Access Compliance Report

Public Rights-of-Way

(Curb Ramps)

Intersection ID: 11739	Main Street: W_9TH_ST	Cross Street: N_CHURCH_ST	Location: E
ADA ID: EB87715309CF	Ramp Type: PerpDiag	Initial Pass/Fail: Fail	Overall Compliance: No
Severity Score: 12.5			
Codes/Mitigation Info/Possible Solution		Field Measurements/Component Compliance

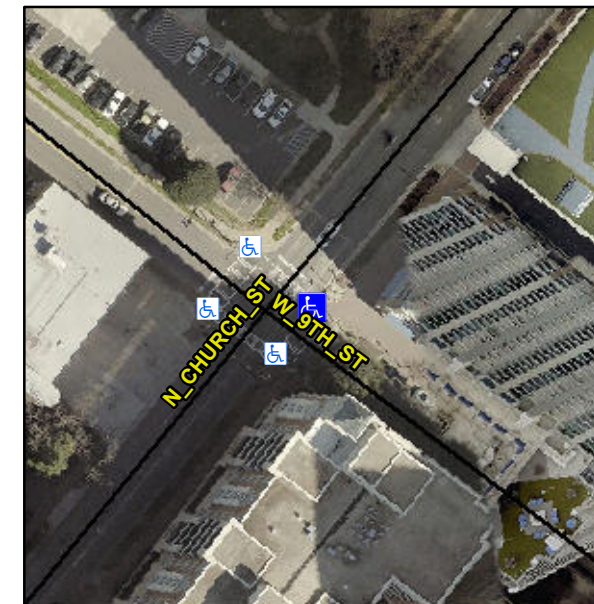
Remove & Replace Curb Ramp With Two New Directional Ramps or Equivalent.

R304.5.3

Compliance	Description	Data	Compliance	Description	Data
N/A	Ramp Length (in)	92.0	Yes	Ramp Slope (%)	5.6
Yes	Ramp Width (in)	119.0	No	Ramp XSlope (%)	6.1
N/A	Flare Type LT	N/A	N/A	Flare Type RT	N/A
N/A	Flare Slope LT (%)	N/A	N/A	Flare Slope RT (%)	N/A
N/A	Flare Traversable LT?	N/A	N/A	Flare Traversable RT?	N/A
N/A	Landing Length (in)	N/A	N/A	DWS Provided?	N/A
N/A	Landing Width (in)	N/A	N/A	DWS Contrast?	N/A
N/A	Landing Slope (%)	N/A	N/A	DWS Length (in)	N/A
N/A	Landing X Slope (%)	N/A	N/A	DWS Full Width?	N/A
N/A	Landing Curb? (Y/N)	N/A	N/A	DWS Offset (in)	N/A
N/A	Shared Landing?	N/A			
N/A	Gutter Ponding?	N/A	N/A	Gutter Slope (%)	N/A
N/A	Gutter Lip Ht (in)	N/A	N/A	Gutter X Slope (%)	N/A
N/A	Painted X Walk1?	Yes	N/A	Painted X Walk2?	Yes
	X Walk 1 Direction	To NW		X Walk 2 Direction	To SW
N/A	X Walk 1 Width (in)	72.0	N/A	X Walk 2 Width (in)	109.0
	X Walk 1 Slope (%)	3.7		X Walk 2 Slope (%)	0.3
	X Walk 1 X Slope (%)	0.5		X Walk 2 X Slope (%)	2.0
